Subject: MHI's Responses to US-APWR DCD RAI No.252-1968

Reference: 1) "Request for Additional Information No. 252-1968 Revision 0, SRP Section: 09.02.02 – Reactor Auxiliary Cooling Water Systems, Application section:9.2.8 Turbine Component Cooling Water System," dated March 2, 2009.

Responses to Request for Additional Information
No. 252-1968 Revision 0

RAI NO.: NO. 252-1968
SRP SECTION: 09.02.02 - REACTOR AUXILIARY COOLING WATER SYSTEMS
APPLICATION SECTION: 9.2.8 TURBINE COMPONENT COOLING WATER SYSTEM
DATE OF RAI ISSUE: 03/02/2009

Figure 1.7-5 Legend for Piping and Instrumentation Diagrams of Secondary System

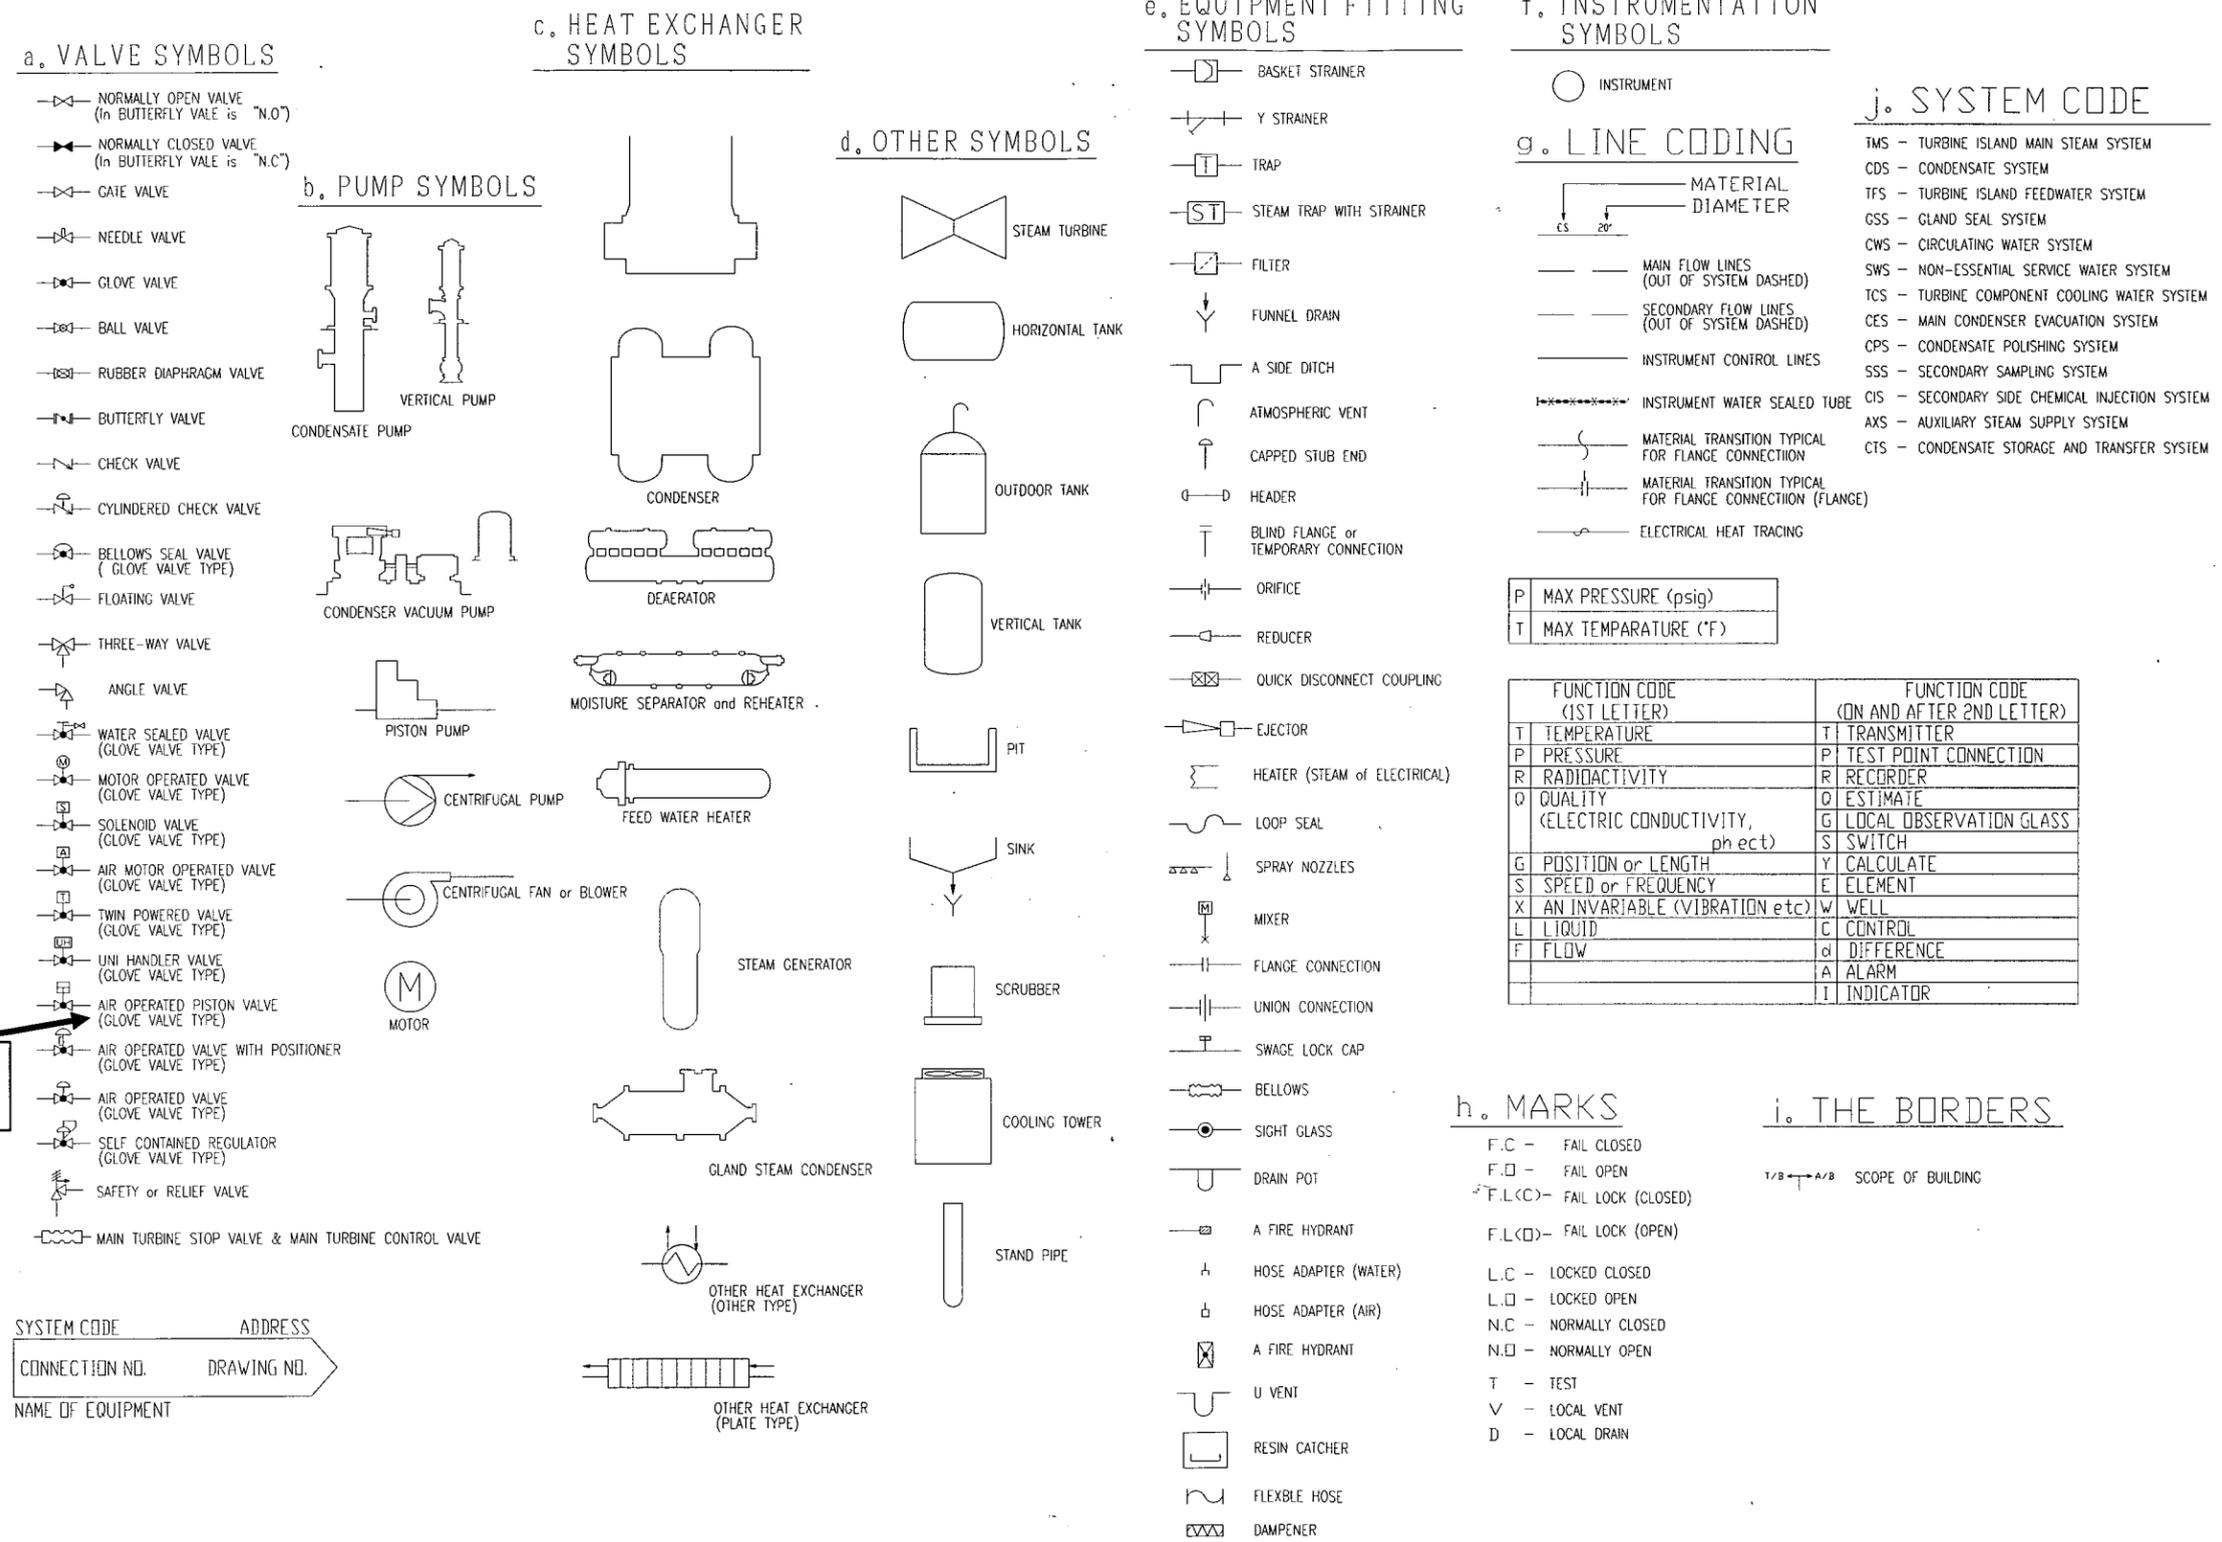
1. The instrument air system are not shown on the flow diagram for the air operated valves for temperature controls and stand pipe makeup which are described in Tier 2, DCD Section 9.2.8.2.2.5.

1. The instrument air system is not shown directly on the flow diagram because "air operated" can be identified by valve symbol. The valve symbol is described in DCD Figure 1.7-5. To clear the operated type, "PISTON VALVE" in Figure 1.7-5 will be changed to "AIR OPERATED PISTON VALVE", as Attachment 1.
2. No external cooling water is required for the TCS pump seals and motors.
3. Concerning the control of valves and other design features of the system arrangement that minimizes the potential for transient water hammer, a statement that a stand pipe is provided to maintain the net positive suction head for the TCS pumps is addressed in the third paragraph of DCD Subsection 9.2.8.2.1. This ensures a pressurized water solid closed loop. In addition, since a stand pipe is installed, TCS system operation can be performed as addressed in DCD Subsection 9.2.8.2.3.

1. Figure 1.7-5 will be revised as follows:

See Attachment 1 for mark-ups of DCD Figure 1.7-5.

Modify the denomination.

Figure 9.2.8-1 Turbine Component Cooling Water System Piping and Instrumentation Diagram

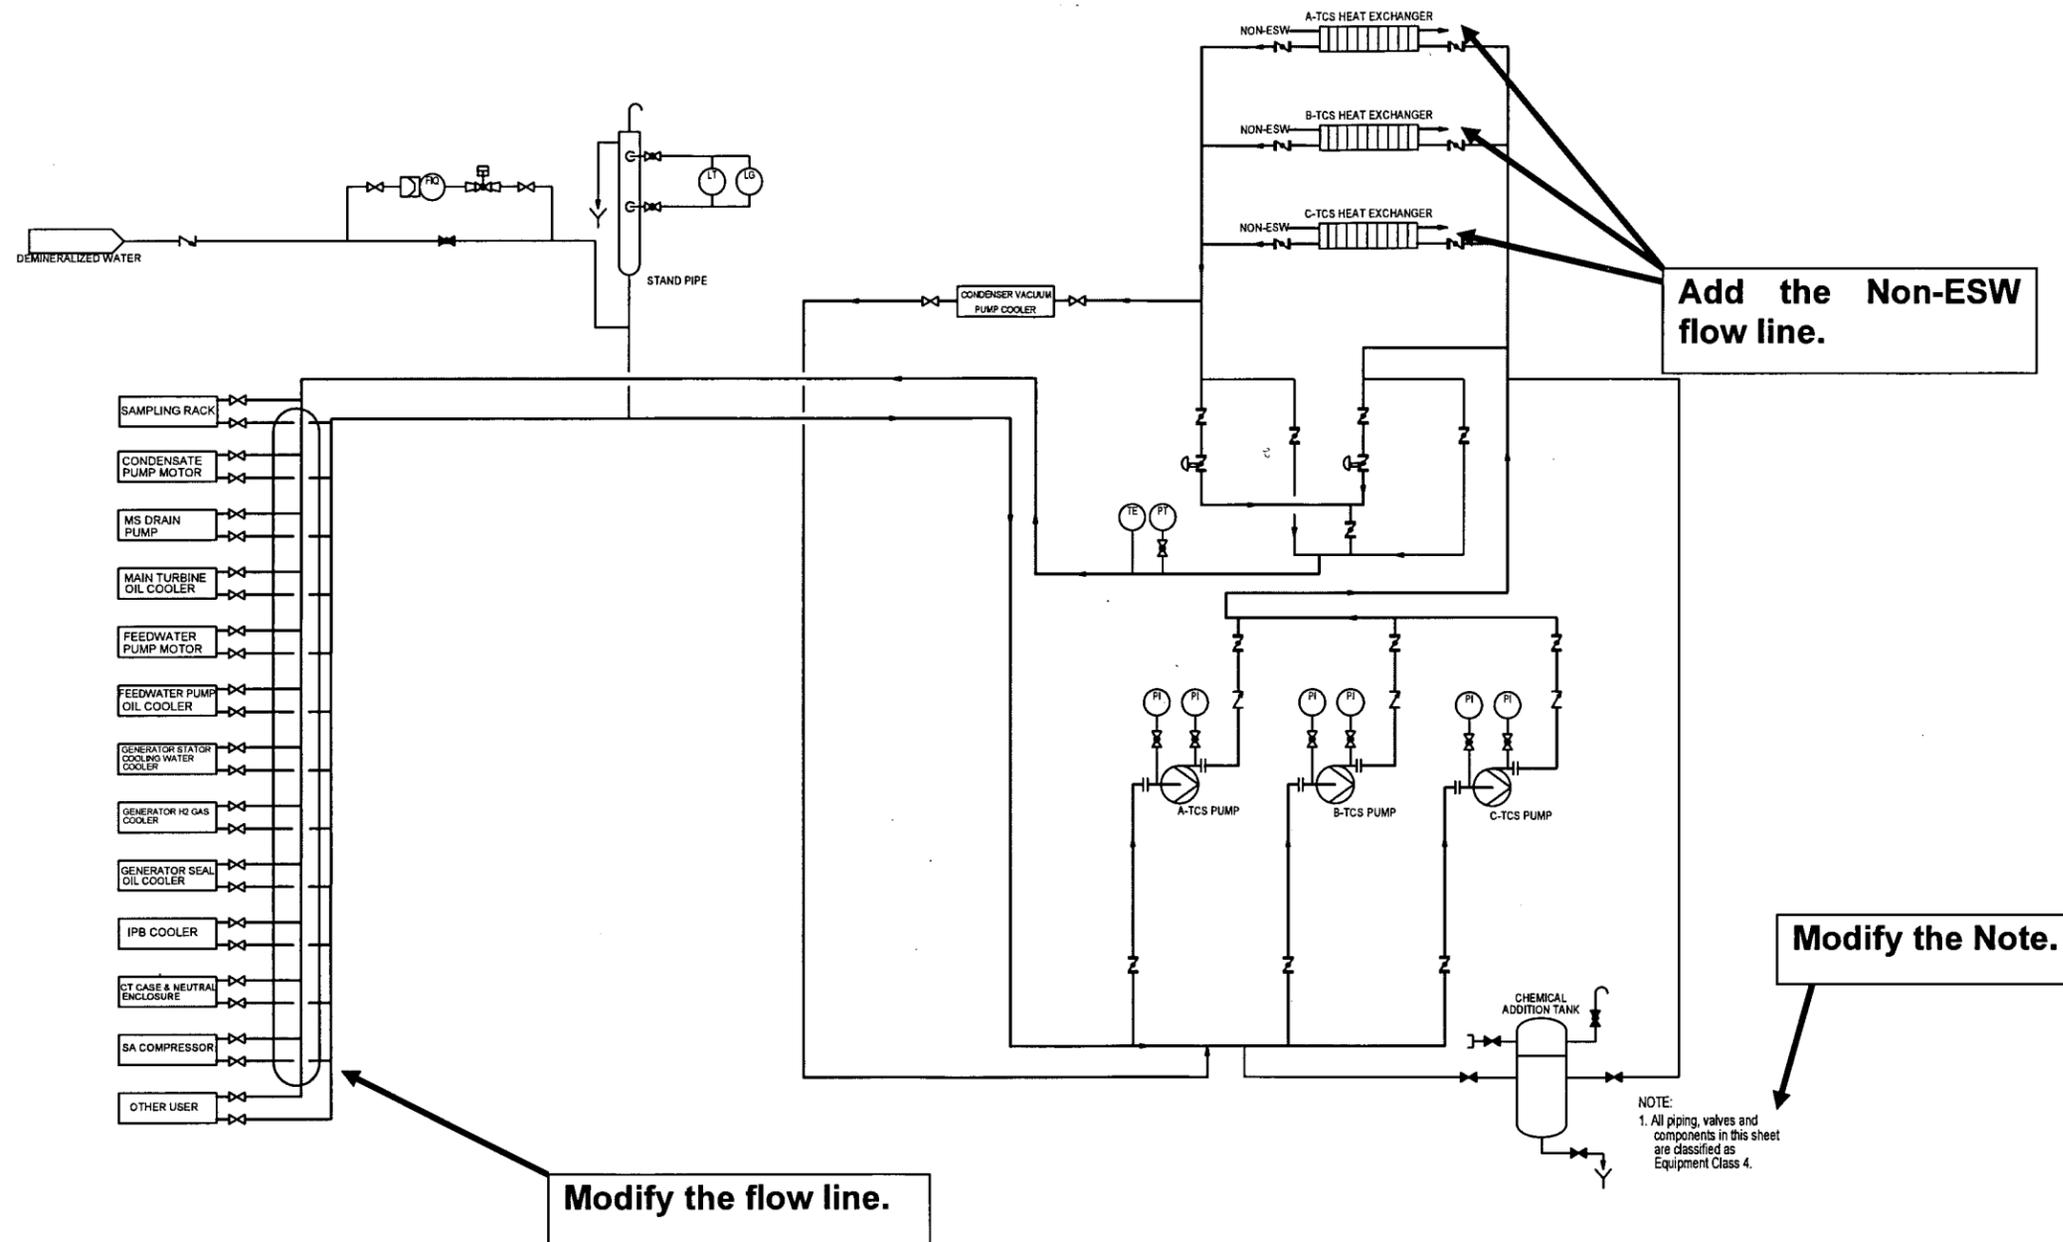
4. Table 9.2.8-1, "TCS Component Parameters," is not noted in the Tier 2, DCD Section 9.2.8.
5. The "Note" beside the chemical addition tank on Tier 2, DCD Figure 9.1.8-1 is missing information.

7. Describe if the TCS pumps received a trip signal on low standpipe level due to net positive suction head consideration.
8. Describe if a dike will be placed around the stand pipe atmospheric vent to capture any system chemical from entering the floor drain system. Normally added corrosion inhibitors should be prevented from entering any water waster systems.
9. The cooling water flow from the non essential service water system is missing from Tier 2, DCD Figure 9.1.8-1 at the TCS heat exchangers.
10. Tier 2, DCD Figure 9.1.8-1 flow lines to the loads are confusing. The flow lines appears to be touching and give the reviewer a sense that cooling supply lines and cooling return lines are interconnected.

5. The "Note" beside the chemical addition tank on Figure 9.2.8-1 is in error, so Figure 9.2.8-1 will be revised as Attachment 2.
6. TCS pump swaps are performed, but TCS heat exchanger flushing is not performed. The TCS piping system and heat exchanger can be operated at higher system flow conditions where three pumps may be operating during pump swaps.

7. TCS pumps do not received a trip signal on low standpipe level due to net positive suction head consideration.
8. A dike will not be placed around the stand pipe atmospheric vent, however a funnel drain for overflow is placed as shown in Figure 9.2.8-1. Fluid captured by the funnel drain is routed to the floor drain system.

9. The non-essential service water system (Non-ESW) is missing on Figure 9.2.8-1, so Figure 9.2.8-1 will be revised as Attachment 2.
10. Figure 9.2.8-1 flow lines are confusing, so Figure 9.2.8-1 will be revised as Attachment 2.

5. Figure 9.2.8-1 will be revised as follows:

See Attachment 2 for mark-ups of DCD Figure.9.2.8-1.

9. Figure 9.2.8-1 will be revised as follows:

See Attachment 2 for mark-ups of DCD Figure.9.2.8-1.

10. Figure 9.2.8-1 will be revised as follows:

See Attachment 2 for mark-ups of DCD Figure.9.2.8-1.
